**Item 14.1.1 - Recommendation in Final Adoption -
(Standard) Amendment No.179 to Town Planning
Scheme No.3 - Additional Use No.1 (Urban Stone/
South Connect) Jandakot**

Attachment 3 Schedule of Submissions

Town Planning Scheme No.3
Amendment No.179
(Standard)

Modifications to 'Additional Use No.1' (AU1) portion of Lots 704-706 Jandakot Road, Jandakot

Table 3.2: The calculation inputs applied to determining the site specific separation distances corresponding to levels of potential radiant heat transfer (including BAL's).

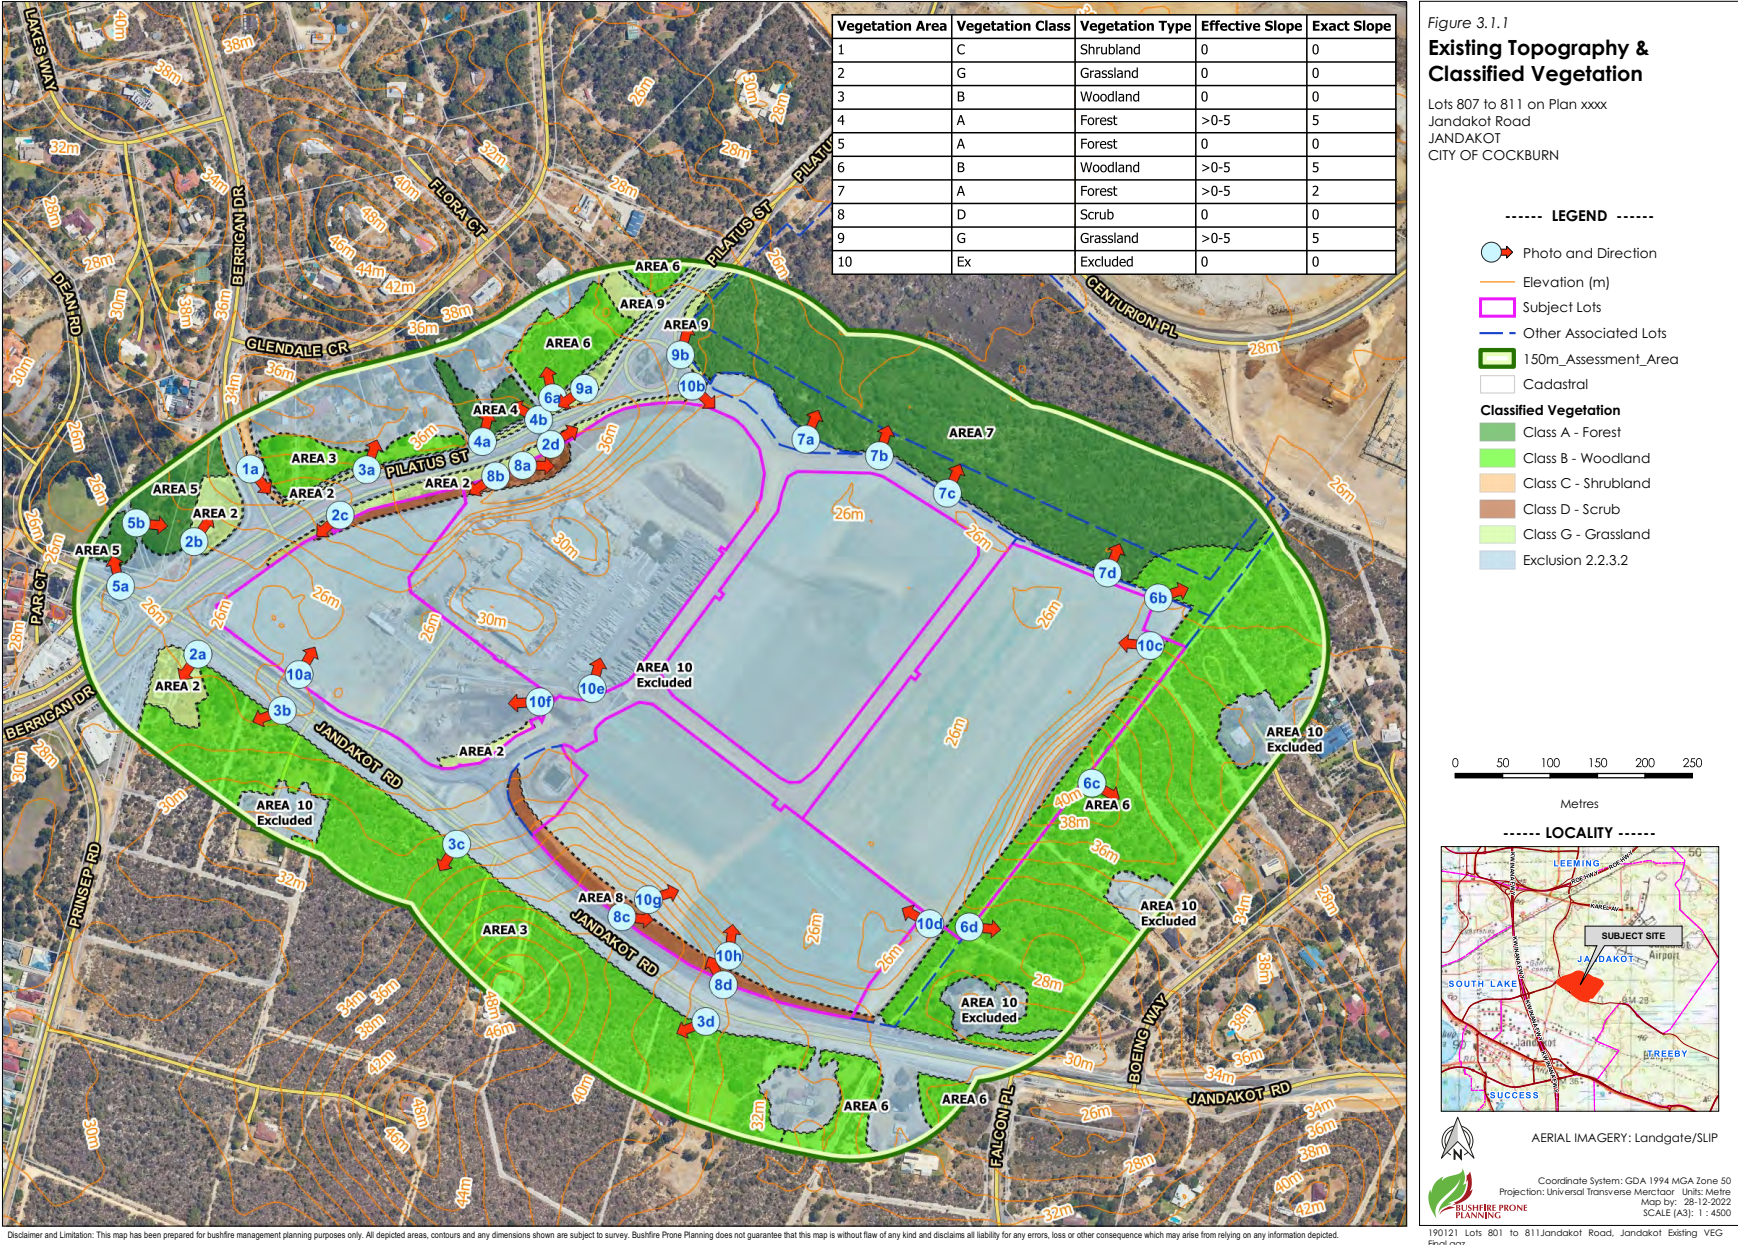
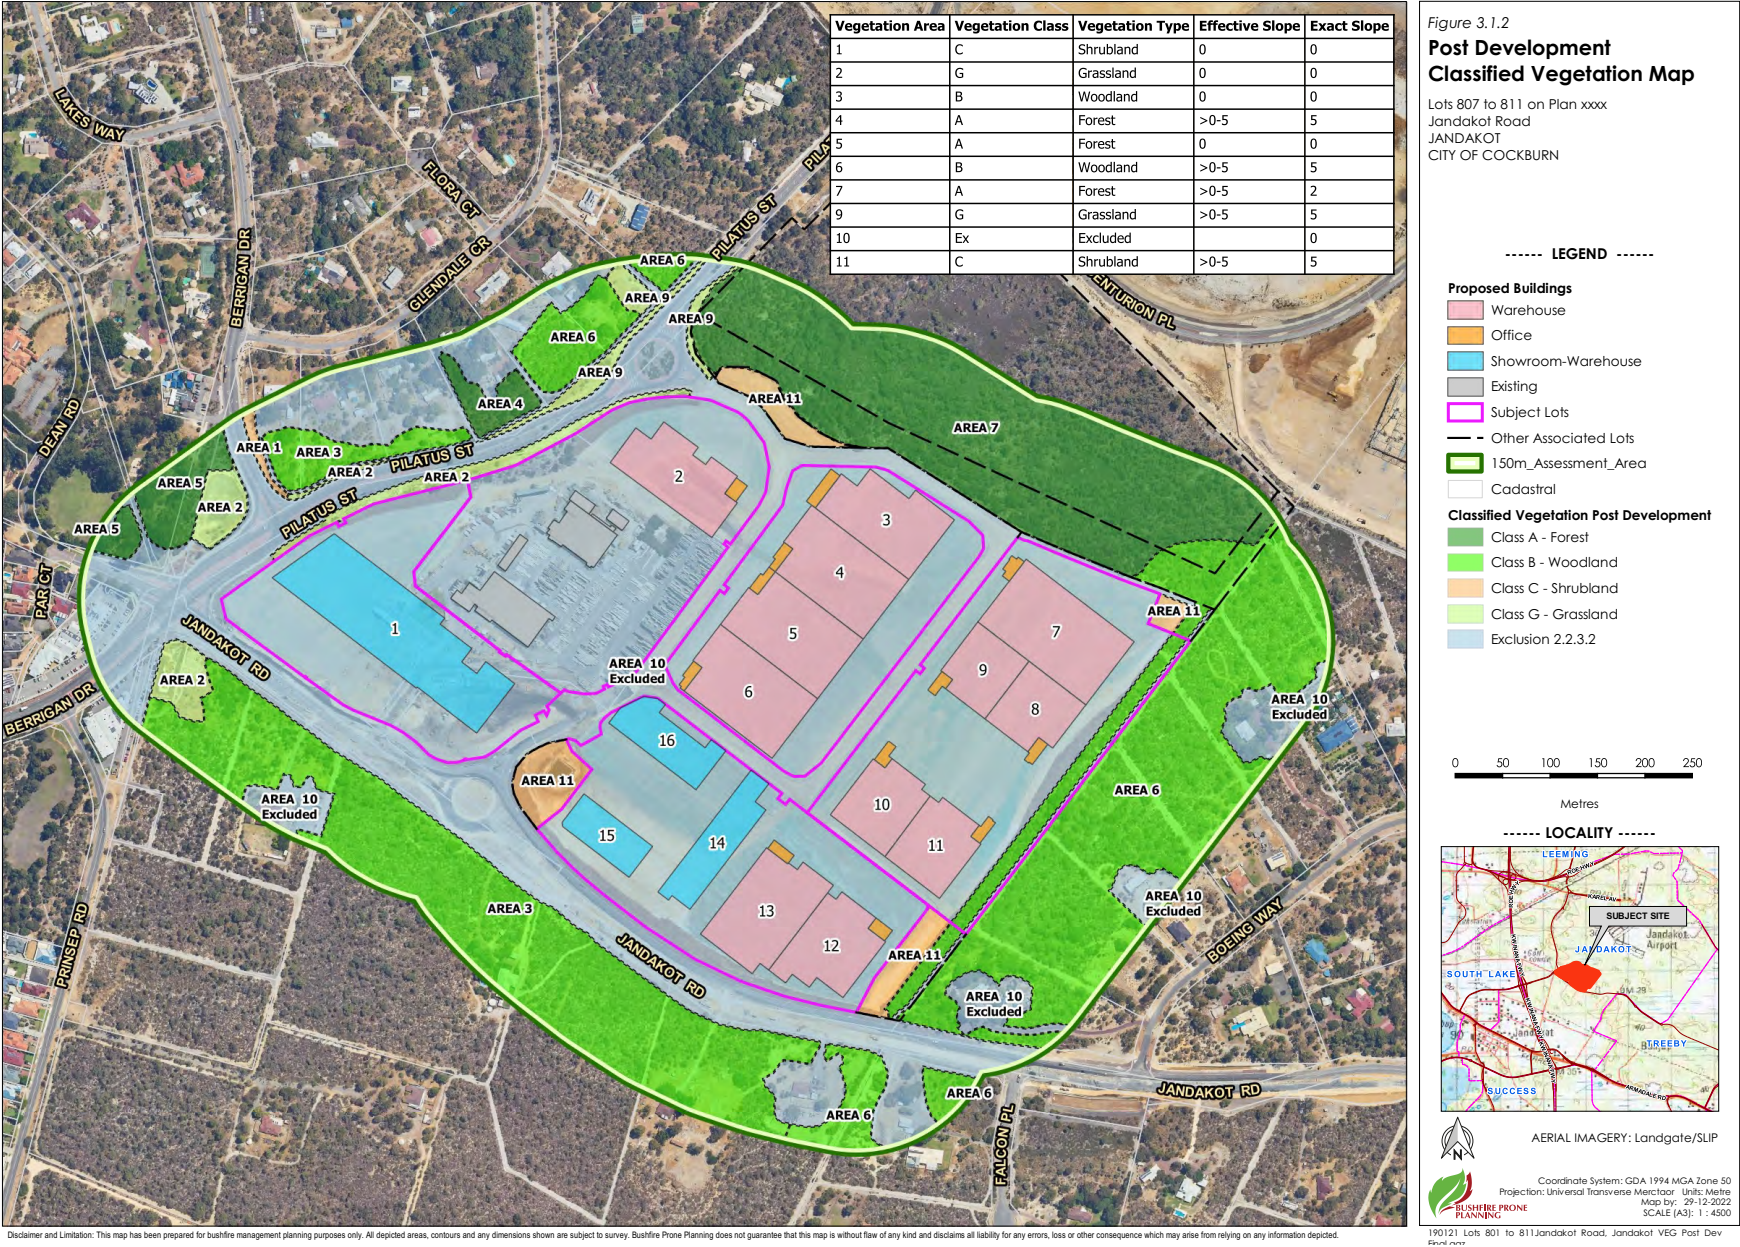
<table><tr><th>Vegetation Classification or Exclusion</th><th>BMP Modification Required</th></tr><tr><td><p><u>Classified Area 8 – not demonstrated</u></p><p>Vegetation area 8 has been inconsistently labelled in the BMP. It is labelled as Class D Scrub on the photos for Area 8 and in Figure 3/1/1 (Vegetation Classification), however in Table 3.2 it is labelled as Class G Grassland with the separation distances for Grassland.</p></td><td></td></tr></table>

Table 3.3: Vegetation separation distances corresponding to the radiant heat levels illustrated as BAL contours in Figure 3.2.

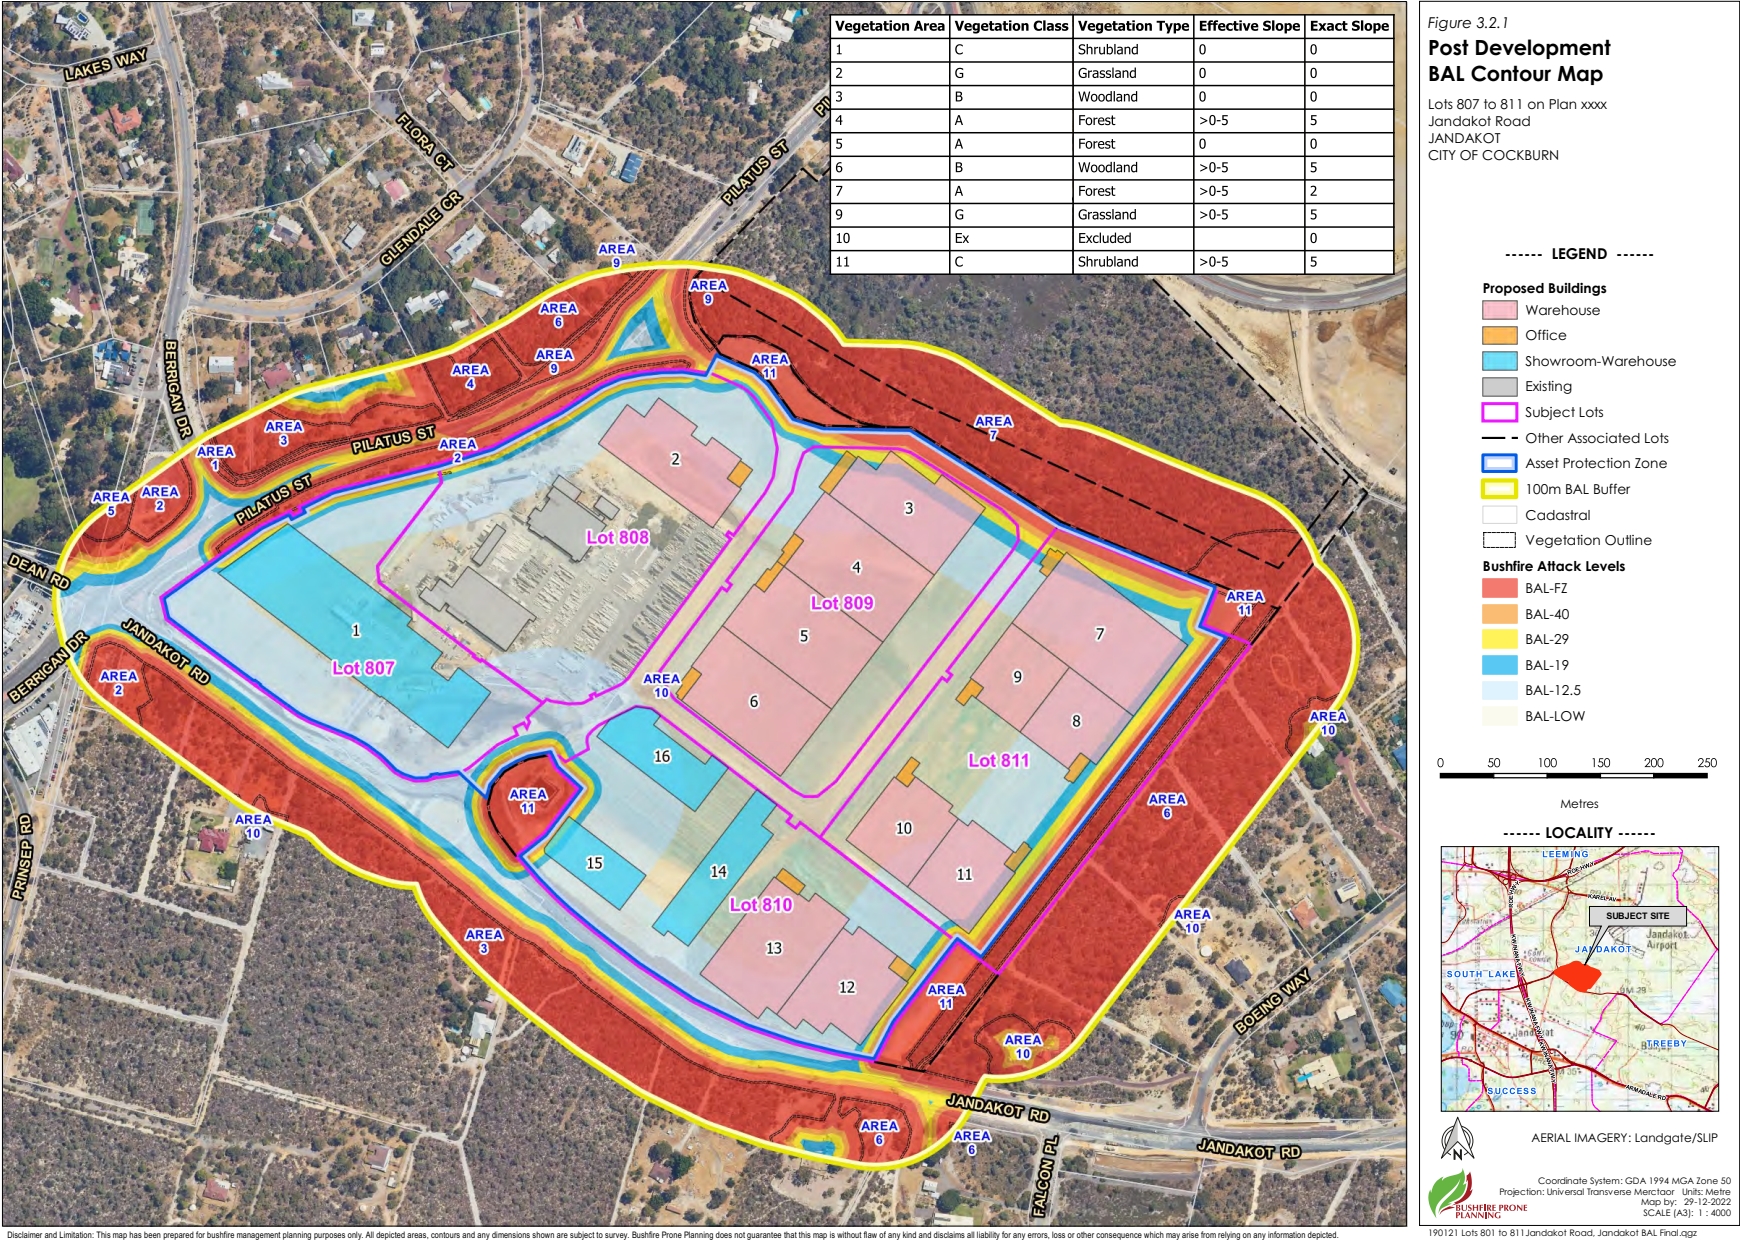
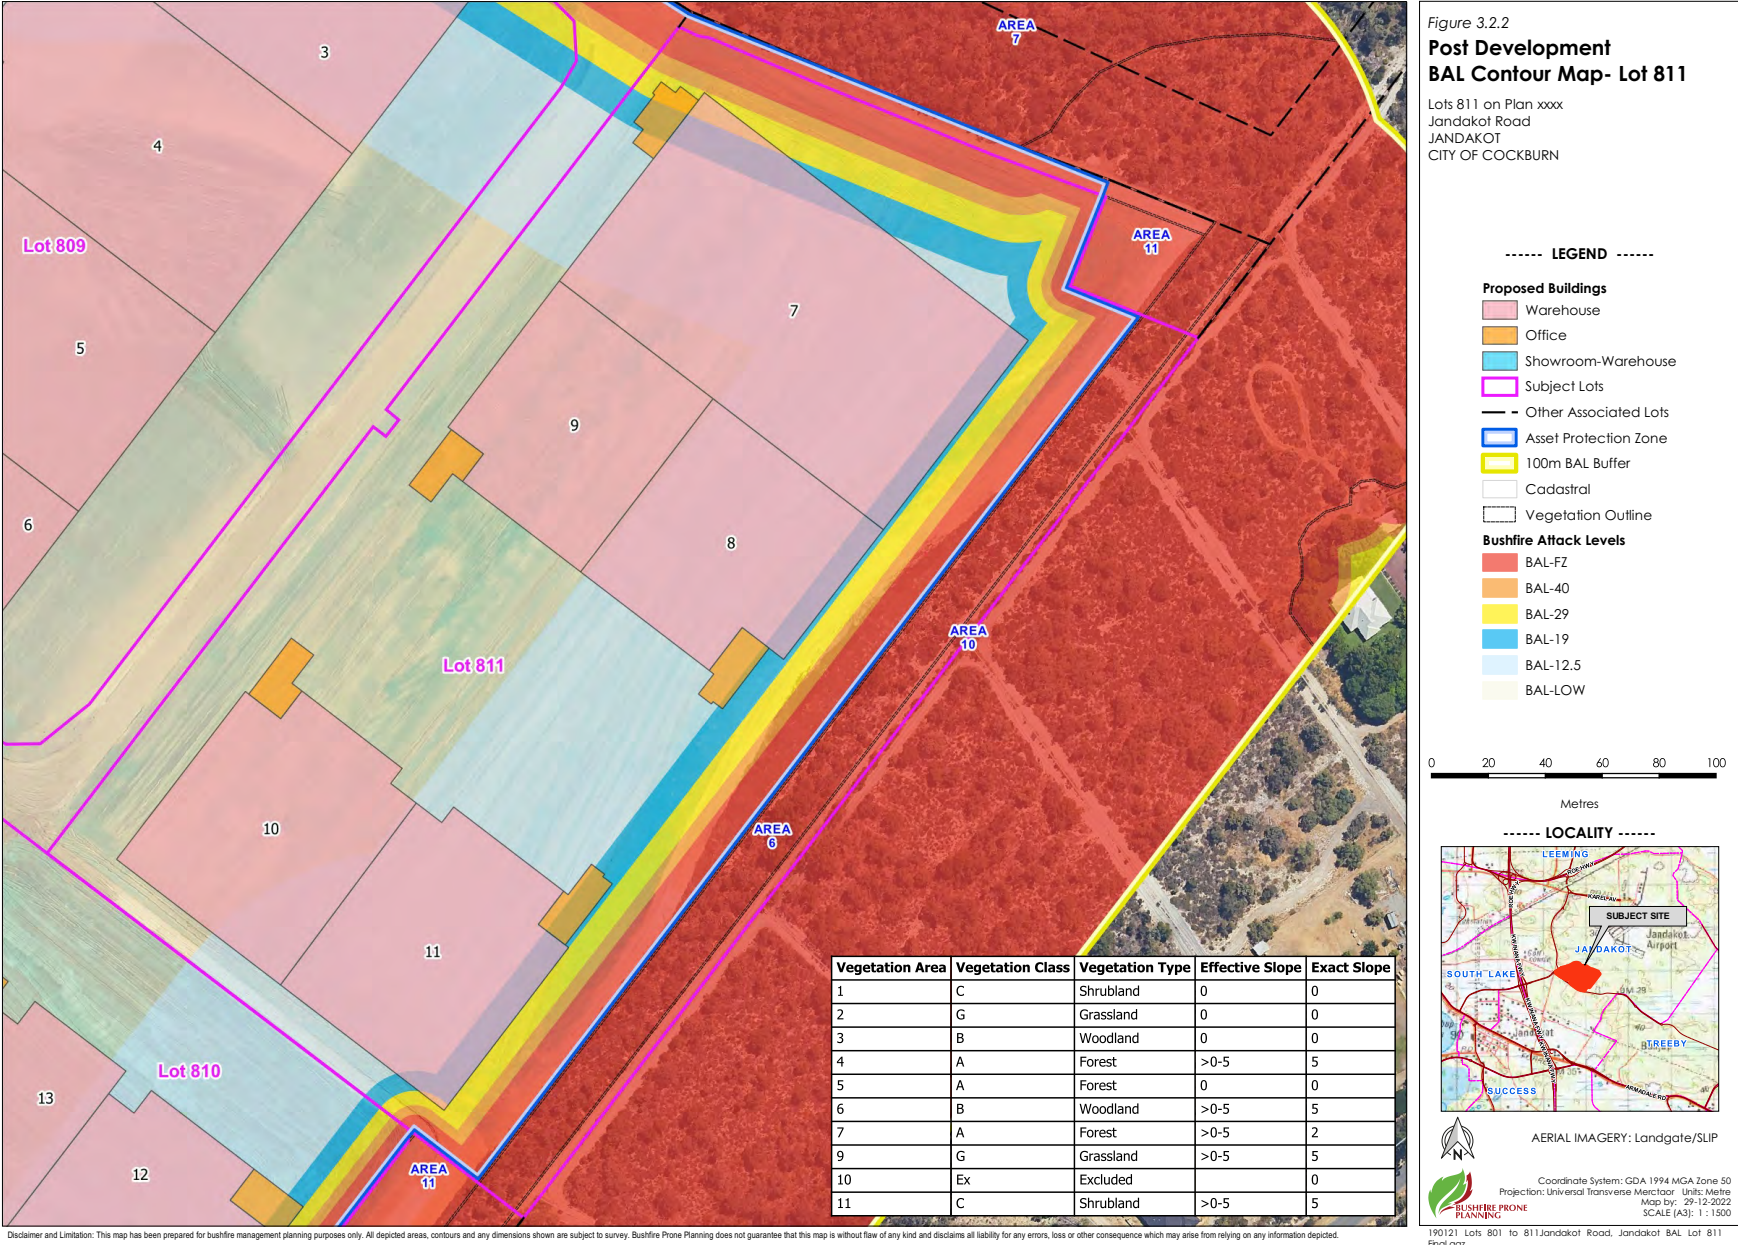
<table><tr><th>Element</th><th>Assessment</th><th>Action</th></tr><tr><td>Siting and Design</td><td>A2.1-A2.2 – not demonstrated The BMP is at a level of detail inappropriate for the planning proposal, it would be more appropriate for a development application. The BAL Contour Map shows future buildings impacted by BAL40/FZ which is considered an extreme hazard. The proposal has not demonstrated that a moderate BHL/or BAL-29 or lower can be achieved with the proposed</td><td>BAL Rating cannot be validated Modification to the BMP is required to address the Assessment advice in Table 1.</td></tr></table>
